Access Compliance Report

Public Rights-of-Way

(Curb Ramps)

Intersection ID: 43644	Main Street: CEDAR_CROSSINGS_DR	Cross Street: KENDRICK_CROSS_RD	Location: NE
ADA ID: 45CD094A87D1	Ramp Type: PerpDiag	Initial Pass/Fail: Fail	Overall Compliance: No
Severity Score: 10			
Codes/Mitigation Info/Possible Solution		Field Measurements/Component Compliance

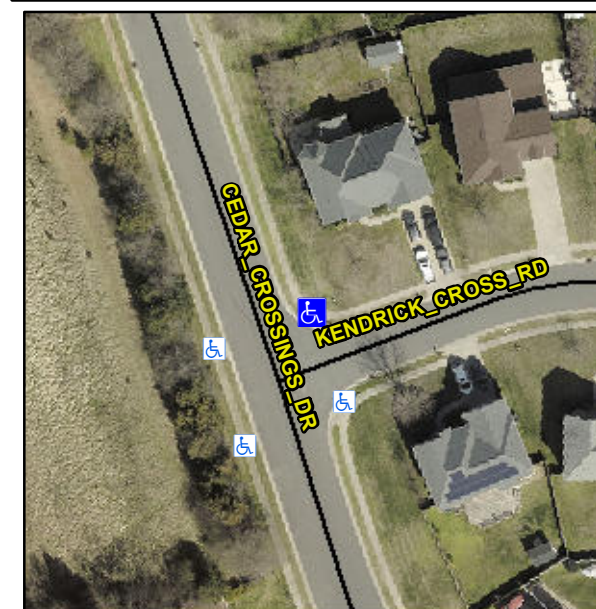
Not Found, R304.5.1, R304.5.3

Compliance	Description	Data	Compliance	Description	Data
N/A	Ramp Length (in)	51.0	Yes	Ramp Slope (%)	5.5
No	Ramp Width (in)	44.0	No	Ramp XSlope (%)	3.8
N/A	Flare Type LT	N/A	N/A	Flare Type RT	N/A
N/A	Flare Slope LT (%)	N/A	N/A	Flare Slope RT (%)	N/A
N/A	Flare Traversable LT?	N/A	N/A	Flare Traversable RT?	N/A
N/A	Landing Length (in)	N/A	N/A	DWS Provided?	N/A
N/A	Landing Width (in)	N/A	N/A	DWS Contrast?	N/A
N/A	Landing Slope (%)	N/A	N/A	DWS Length (in)	N/A
N/A	Landing X Slope (%)	N/A	N/A	DWS Full Width?	N/A
N/A	Landing Curb? (Y/N)	N/A	N/A	DWS Offset (in)	N/A
N/A	Shared Landing?	N/A			
N/A	Gutter Ponding?	N/A	N/A	Gutter Slope (%)	N/A
N/A	Gutter Lip Ht (in)	N/A	N/A	Gutter X Slope (%)	N/A
N/A	Painted X Walk1?	No	N/A	Painted X Walk2?	No
	X Walk 1 Direction	To W		X Walk 2 Direction	To S
N/A	X Walk 1 Width (in)	N/A	N/A	X Walk 2 Width (in)	N/A
	X Walk 1 Slope (%)	2.2		X Walk 2 Slope (%)	2.6
	X Walk 1 X Slope (%)	1.5		X Walk 2 X Slope (%)	0.8

Remove & Replace Curb Ramp With Two New Directional Ramps or Equivalent.
